RE: BENNETTS GREEN BUNNINGS AND BULKY GOODS DEVELOPMENT

1. As requested, we are writing regarding matters raised by council and RMS in relation to the above development. We have previously prepared a report¹ which was submitted with the development application.
2. The council email of 27 September and RMS letters of 26 October 2017 include a number of traffic and parking matters. In response to the matters raised, amended plans have been prepared by the project architect. These matters, and our responses, are set out below.

B99 VEHICLE SWEEP PATHS

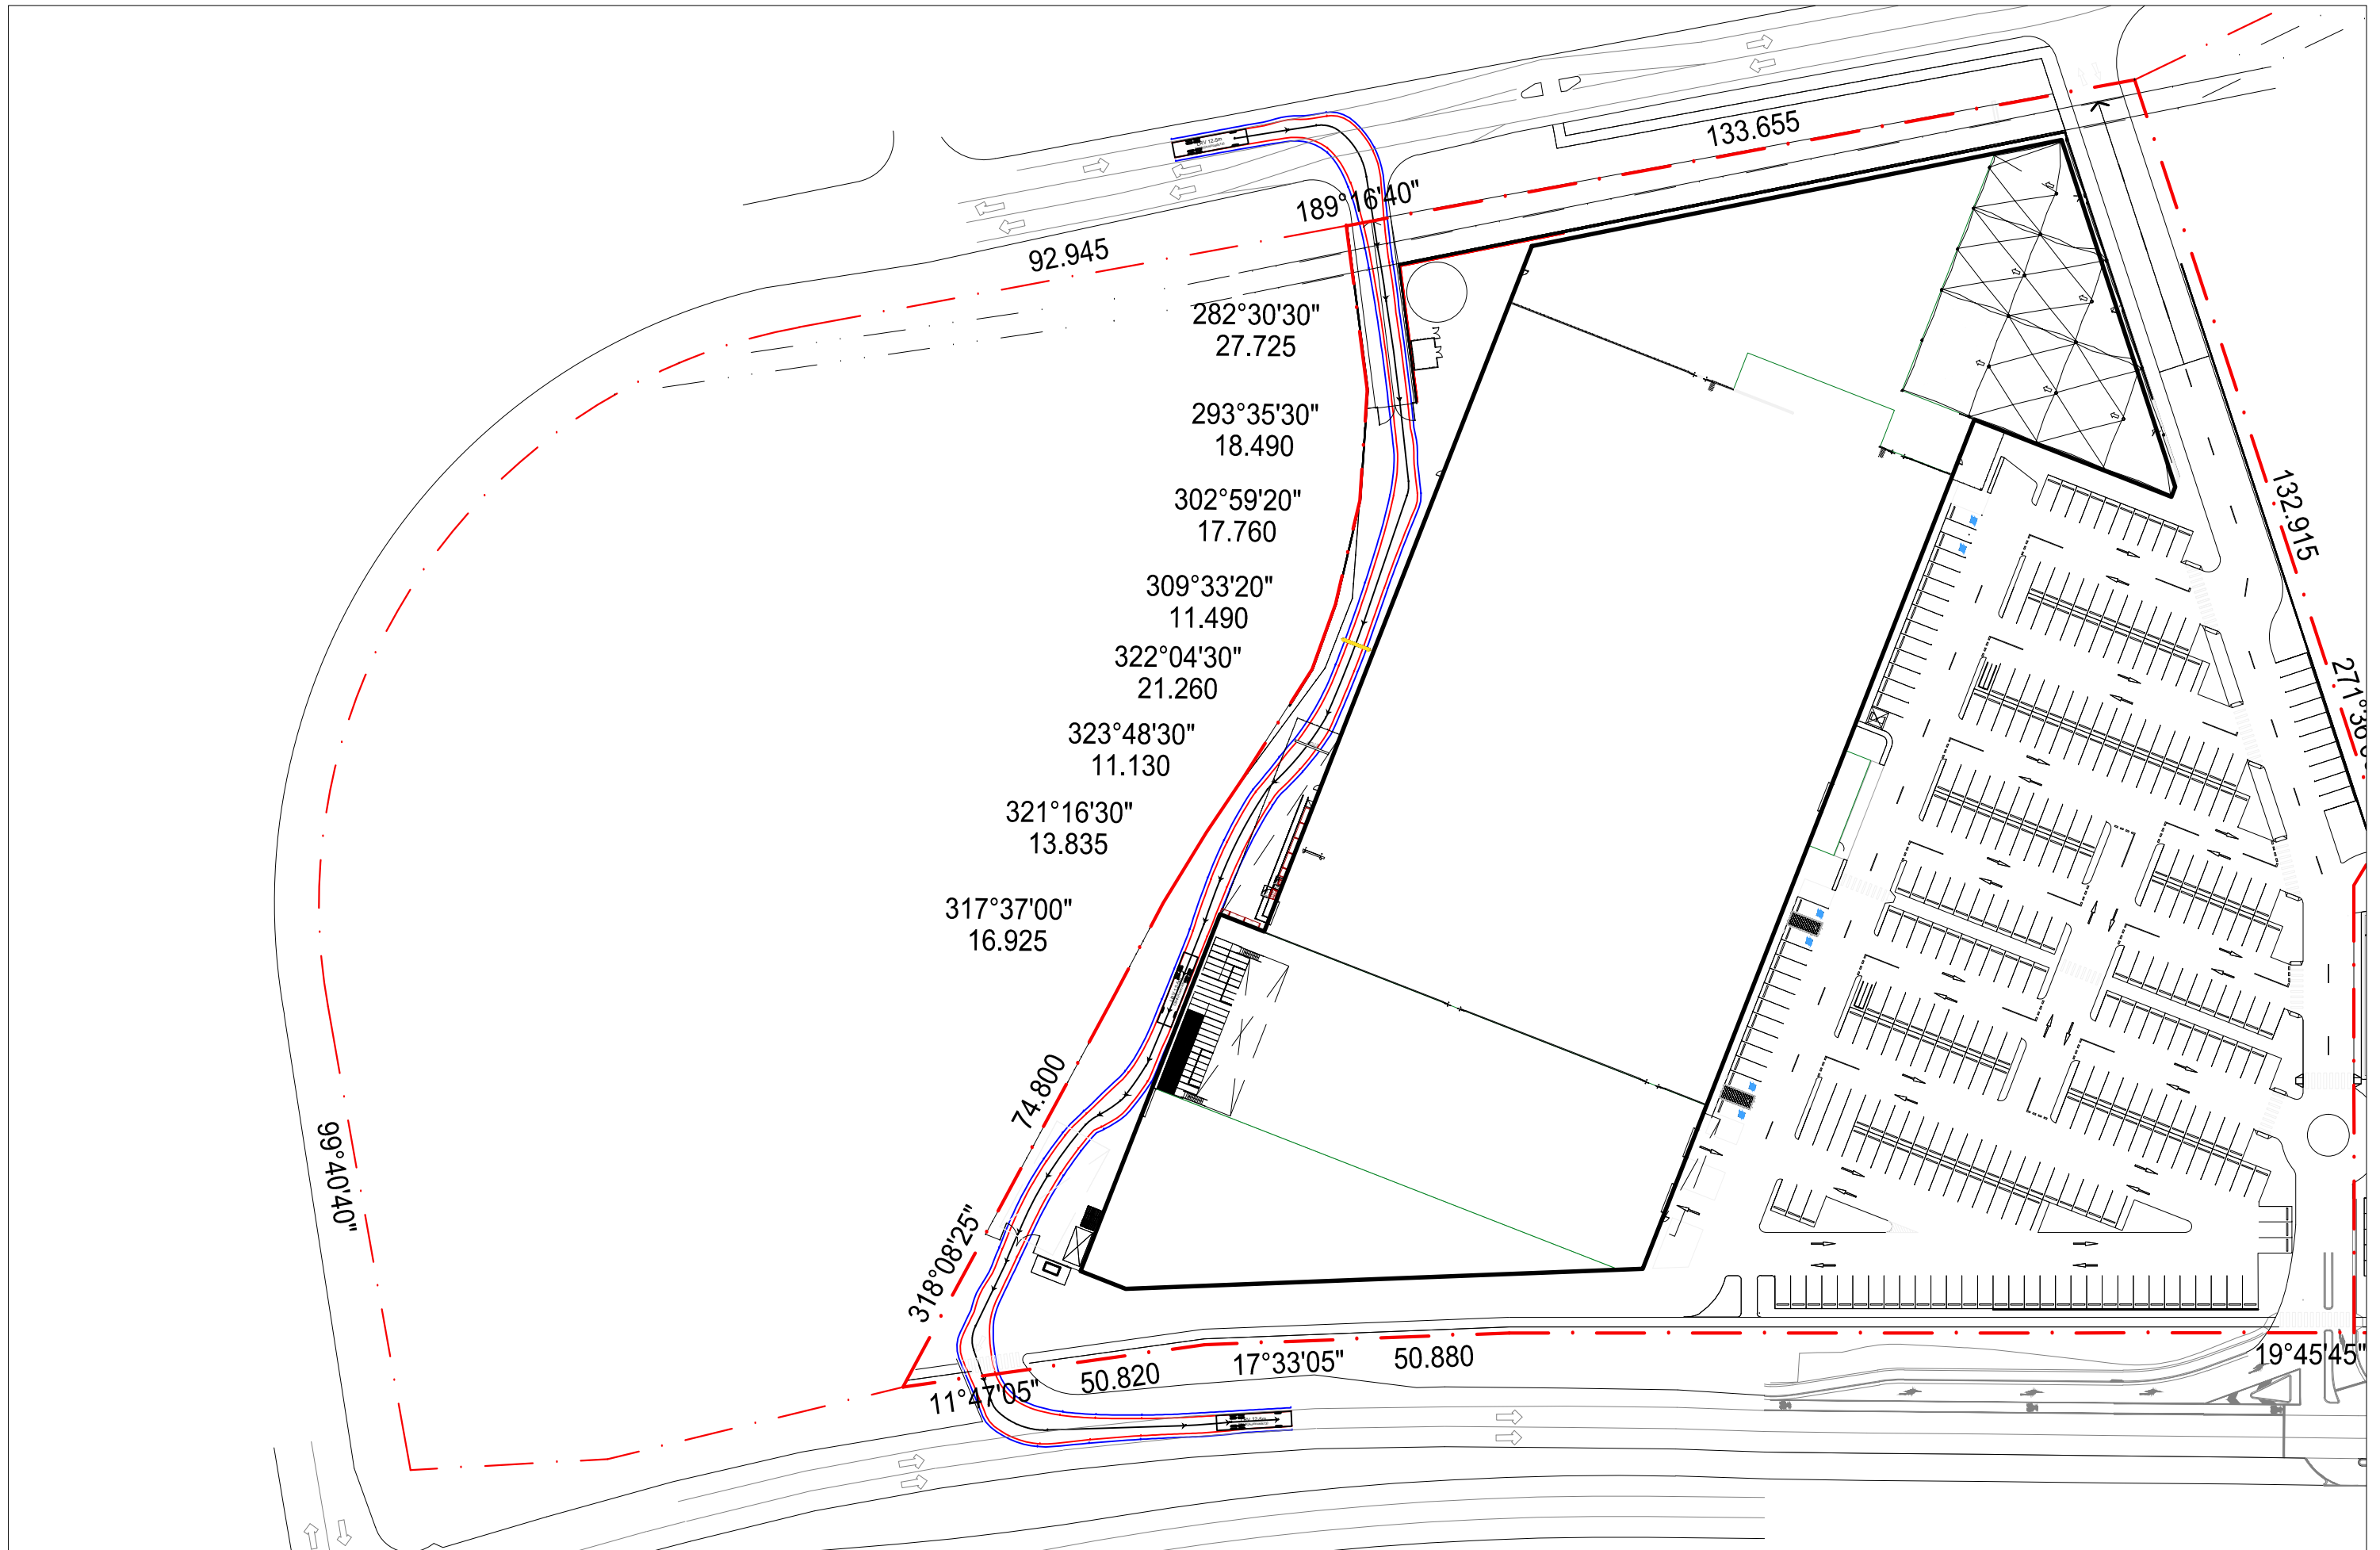
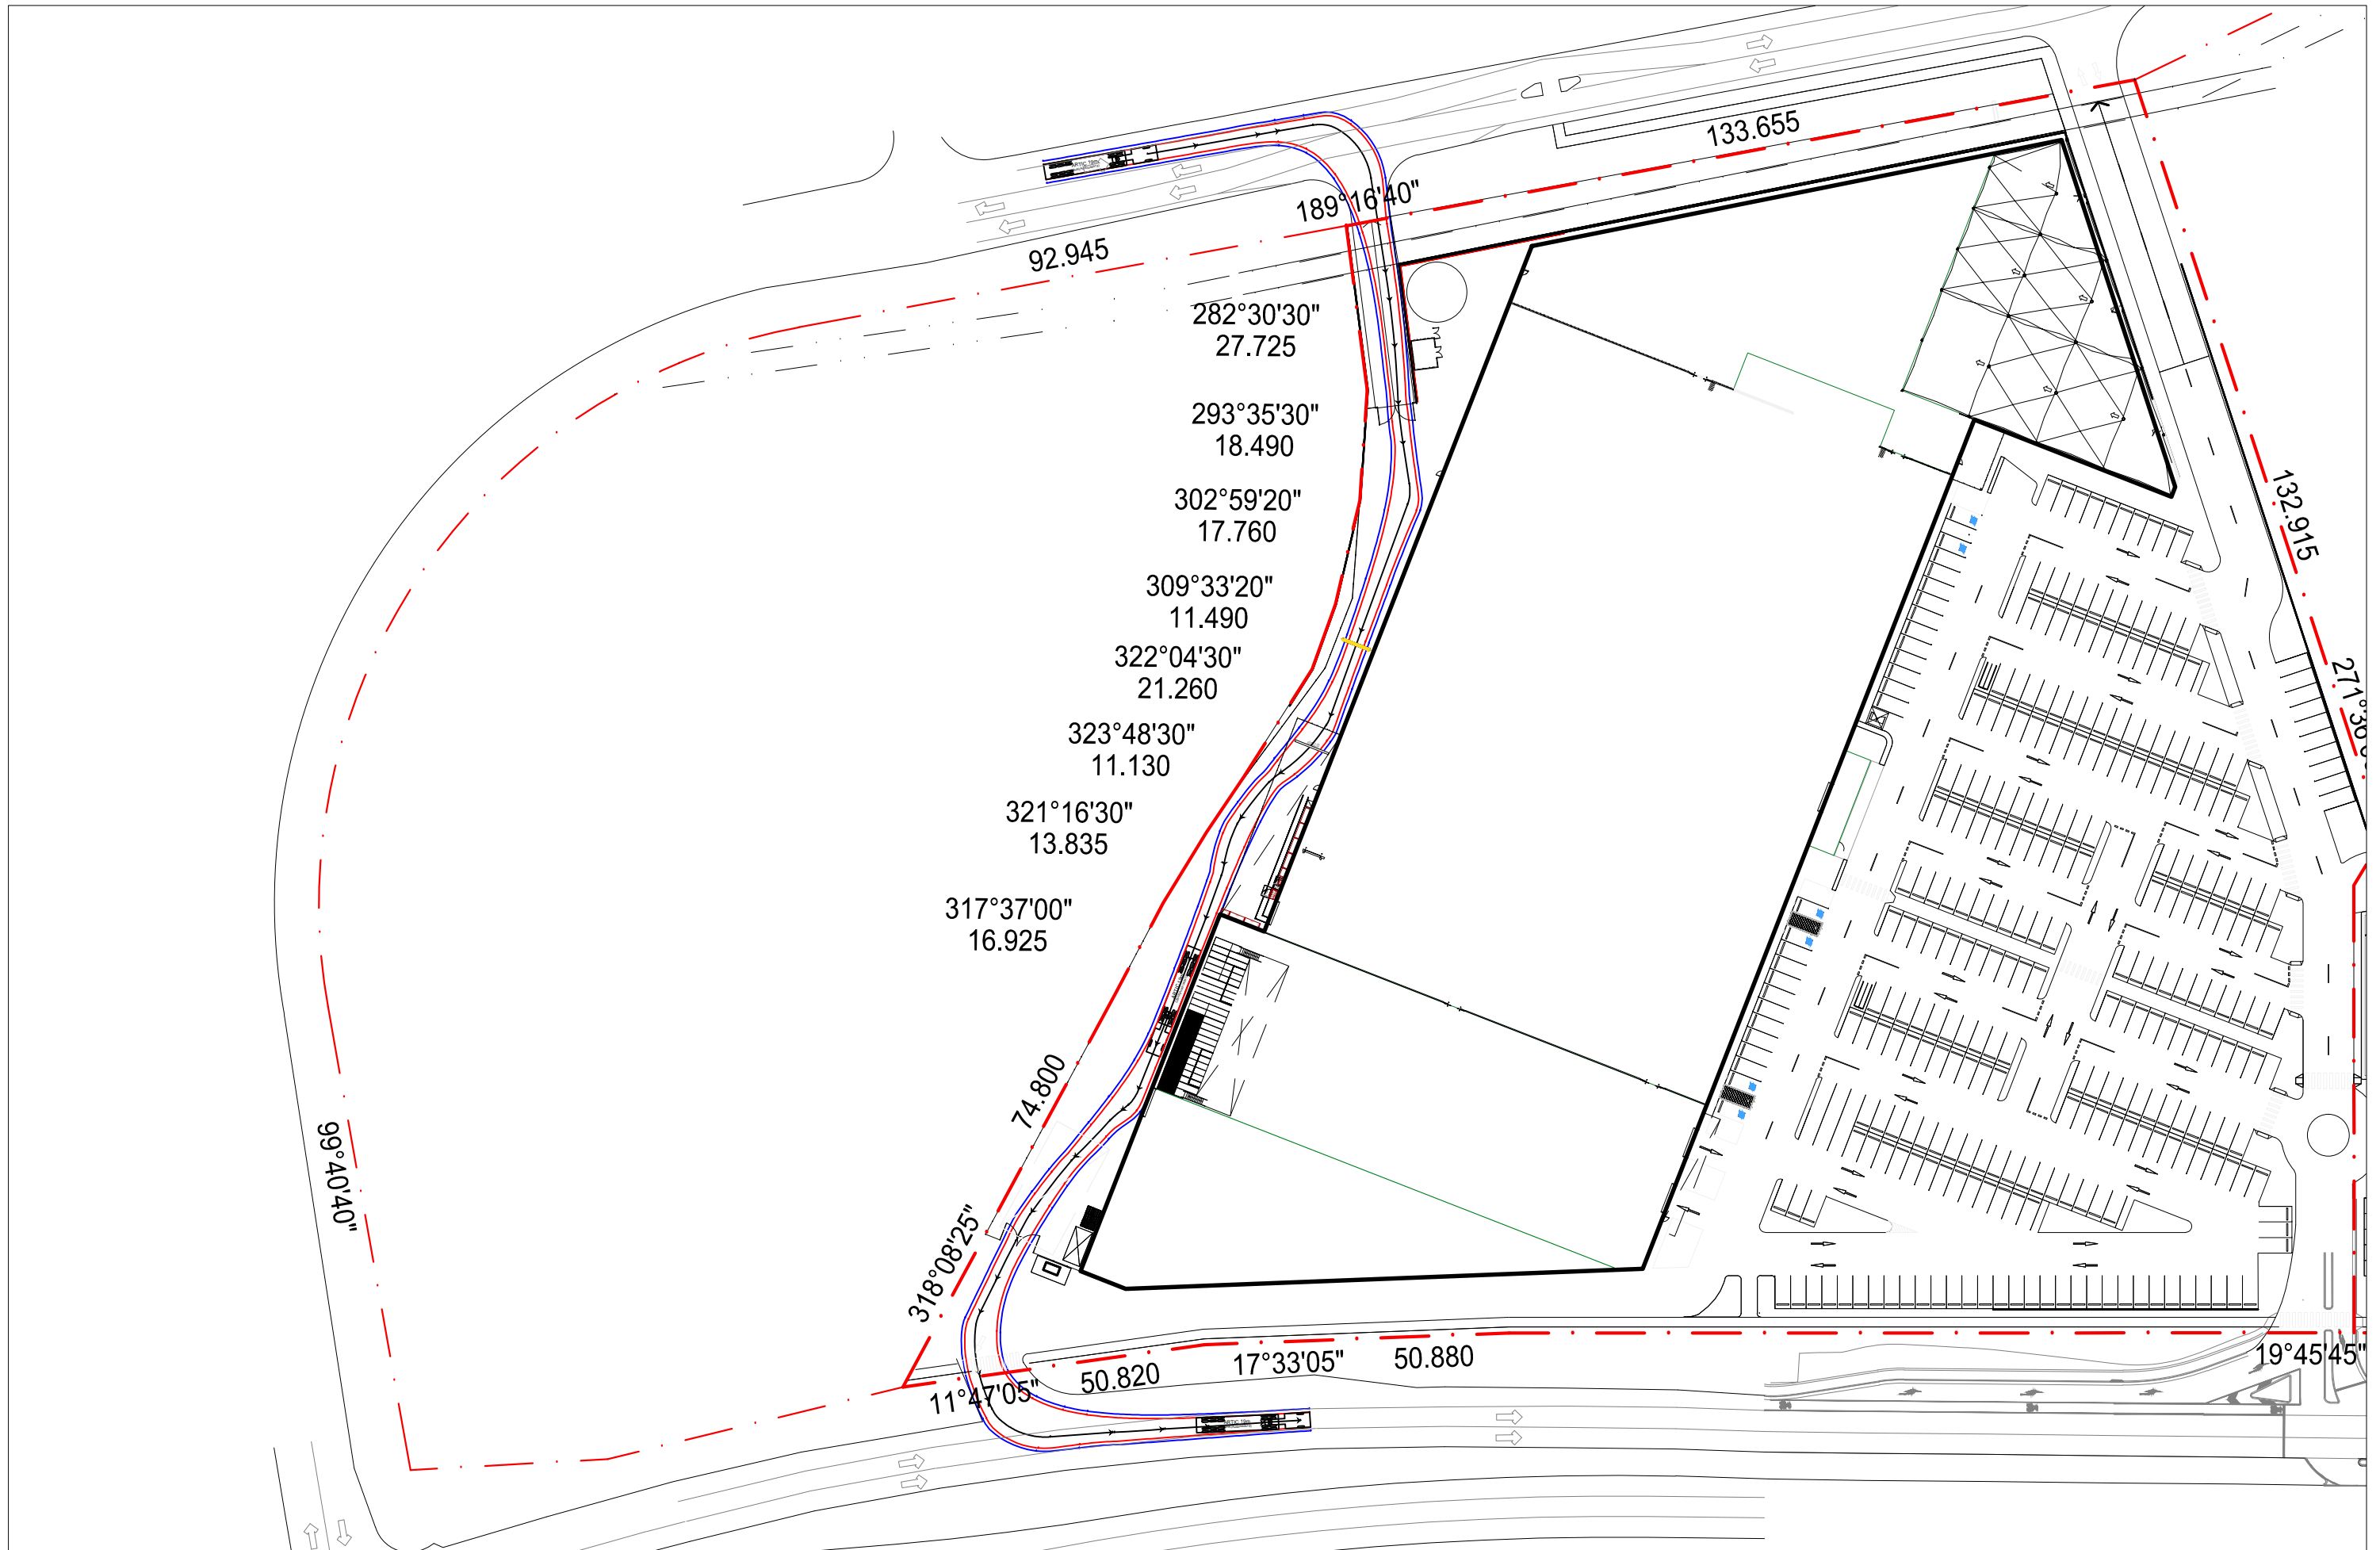
6. The proposed arrangements are therefore considered to be appropriate.
 - *Building Products Warehouse and Showroom*
 - 1) *The access ramp/driveway from South Street to the rear service bay of the Building Products Warehouse and Showroom requires additional detail in the form of widths, clearances and the like, inclusive of swept paths from South Street, through the access ramp and within the service delivery bay...*

- *Servicing*
 - 1) *Details of service vehicles including swept paths are required for internal areas (deliveries and waste collection) for the Building Products Warehouse & Showroom as well as the Bulky Goods Units and Restaurant. Additionally movements at the (Bunnings service vehicles) South Street and the Pacific Highway access points are to be provided.*

- *Details for servicing (deliveries & waste collection) the development are required in terms of manoeuvring/swept paths.*

7. Vehicle swept paths are attached to this letter as Figures 1 to 12.
 - *Parking*
 - 1) *The development provides a total 846 car parking spaces, 13 additional non-discriminatory parking spaces and 2 waiting bays. An assessment based on the proposed GFA identified 697 car parking spaces and 14 non-discriminatory parking spaces as being required. Therefore as an excess in car parking is proposed a reduction is required as per Council's DCP and to improve landscaped outcomes.*

21. Service vehicle swept paths are shown in Figures 1 to 12.

- *The plans are ambiguous as to how vehicles will access the Take Away Food & Drink Premises. It appears vehicles are required to access the drive thru via the entrance of the Service Station, which could become quite congested considering queuing for petrol bowsers. Details are required on how vehicles will access the drive thru and what will prohibit these vehicles travelling on the Service Road in the opposite direction to Service Vehicles.*

16. Vehicles will enter this drive-through from the service station, in a similar manner to many other service station/fast food developments. The swept paths attached in Figure 12 show that with two vehicles queued at the petrol bowers, other vehicles will be able to readily circulate to the drive-through.
17. There will be appropriate no entry signage at the western leg of the roundabout, which will apply to service vehicles and general traffic.
